Eastridge to BART Regional Connector

Second Addendum to the Final Second Supplemental Environmental Impact Report

January 2020

FIGURE 2 - NB OCALA DOUBLE LEFT TURN EXHIBIT

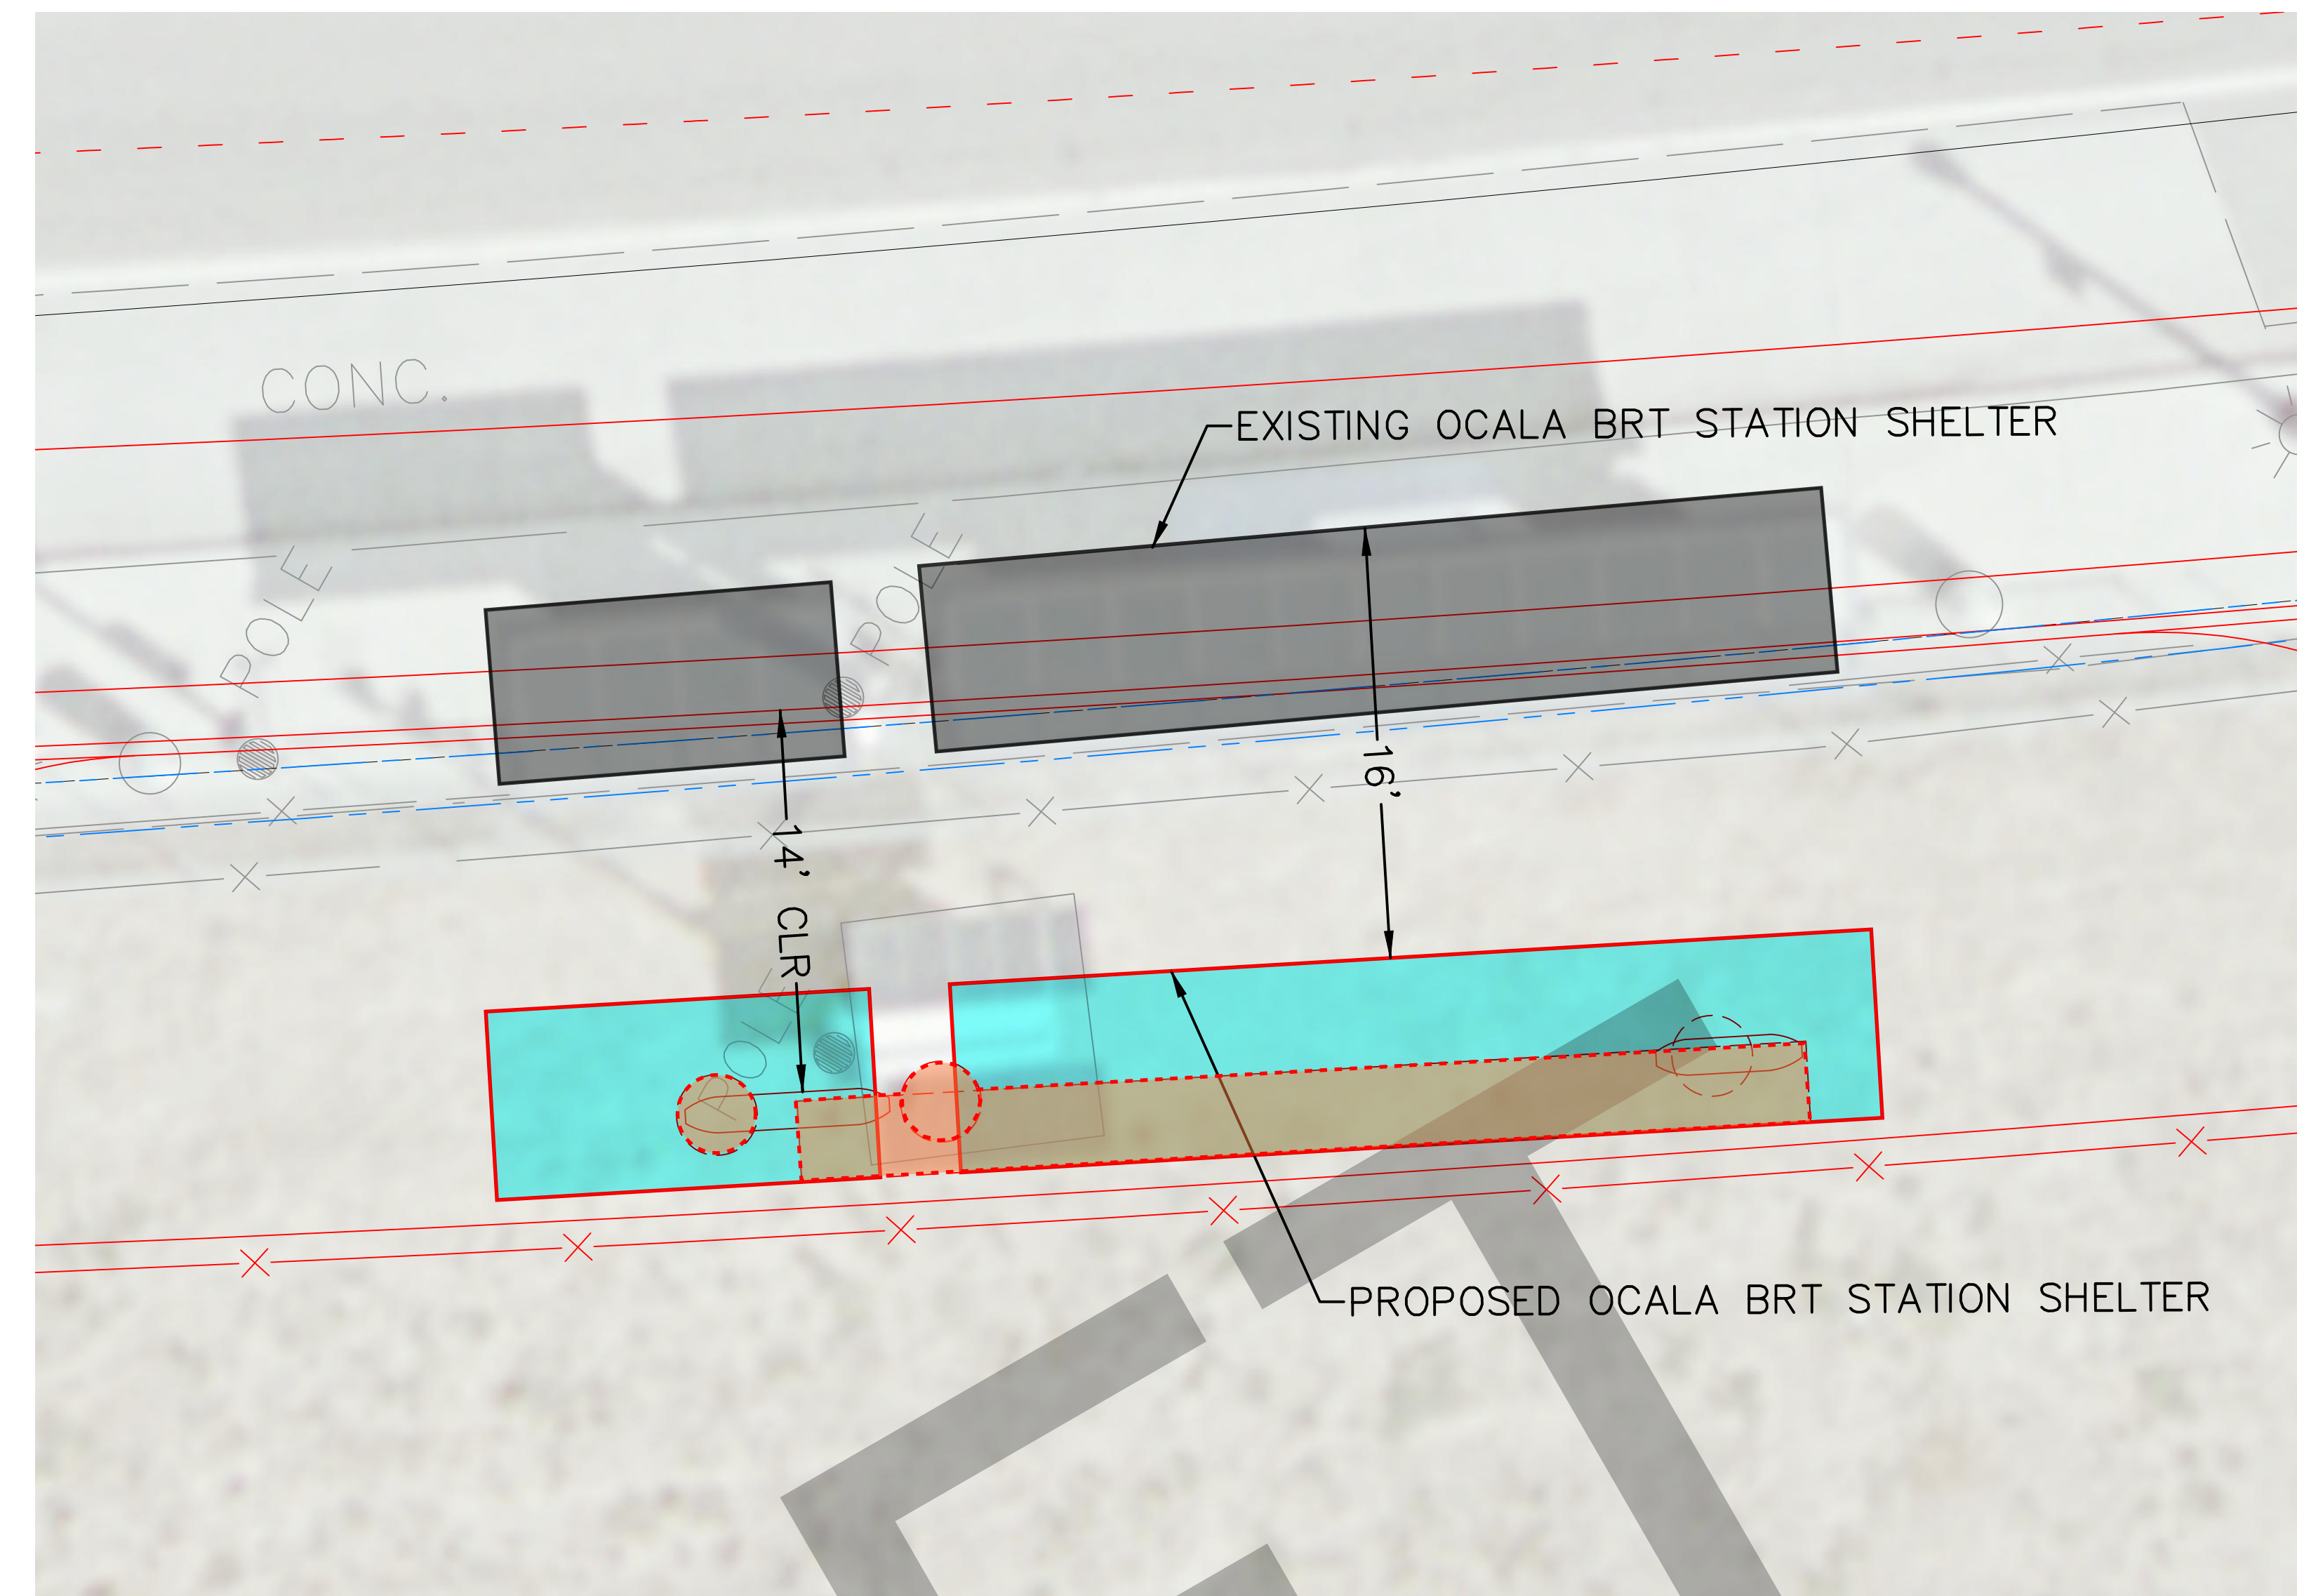
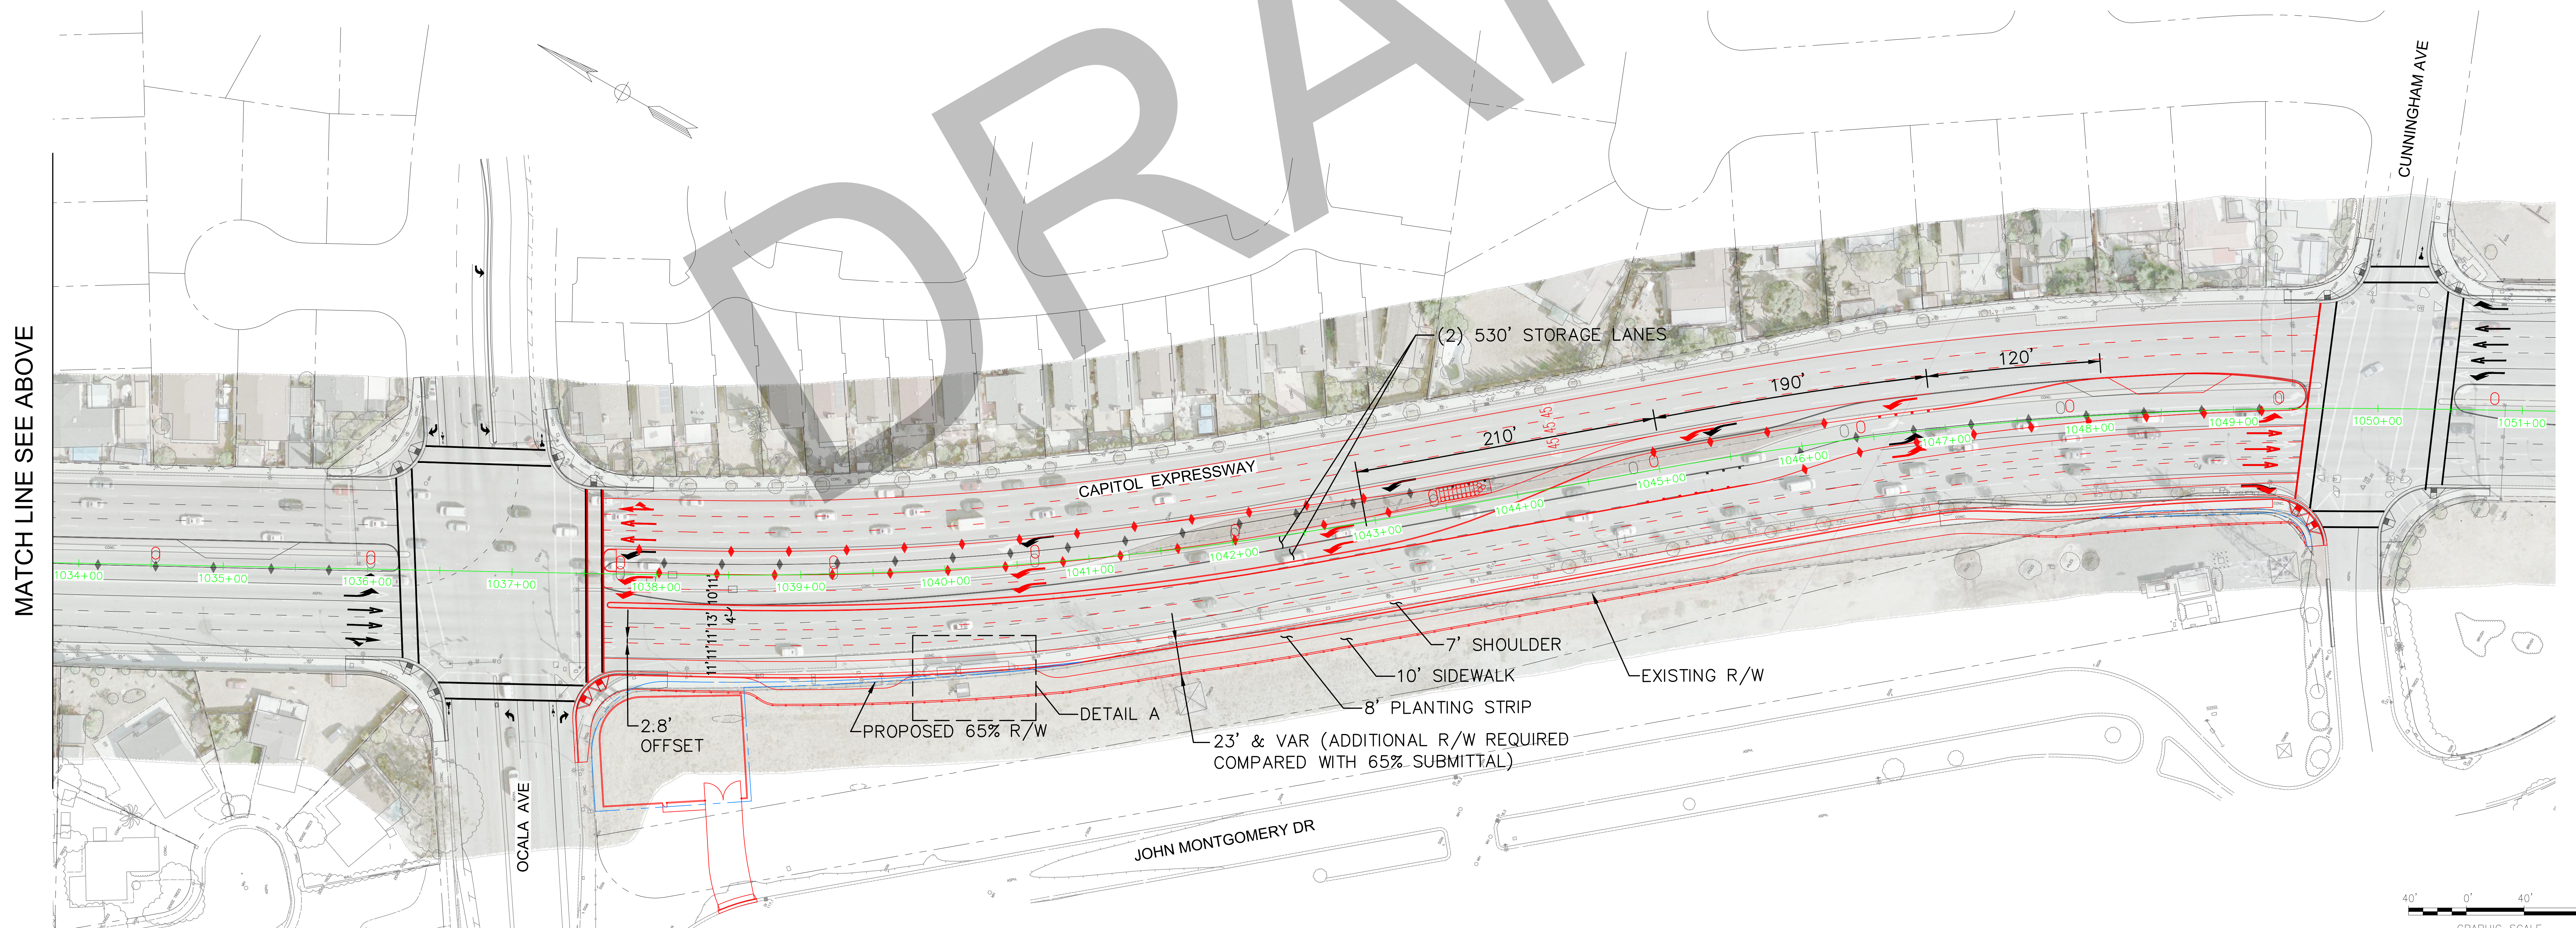
- **Design Change #1 - Maintain an existing second left-turn lane on northbound Capitol Expressway at Ocala Avenue**

VTA is proposing to maintain a second left-turn lane on northbound Capitol Expressway at Ocala Avenue that was previously going to be removed by the Project (Figure 2). This design change will improve traffic operations compared to the original design. Maintaining the second left-turn lane will require that the roadway and aerial guideway alignment be shifted to provide the space needed. Both of the northbound left-turn lanes will be moved from the east to the west side of the aerial guideway (bridge) column and will require the relocation of the existing southbound Bus Rapid Transit (BRT) shelter, and sidewalk. Appropriate safety measures, such as crash cushions and energy absorption devices, will be included in the design. This will result in an increase to the roadway easement required from the County of Santa Clara.

EASTRIDGE PARKING LOT EXHIBIT

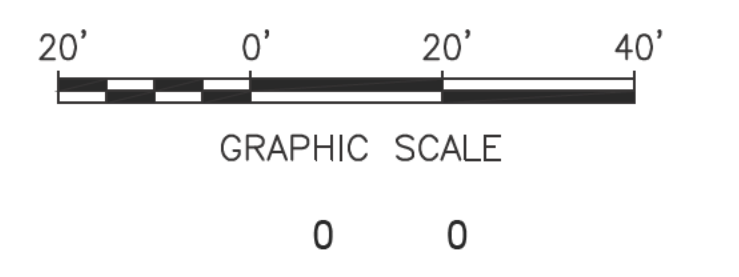
- **Design Change #5 – Include parking canopies with photovoltaic system at Eastridge Park-and-Ride Lot**

The Project will include a 92 kW photovoltaic system on parking canopies located in the Eastridge Park-and-Ride lot to reduce the grid electricity requirements of the light rail station and park-and-ride lot (Figure 3).
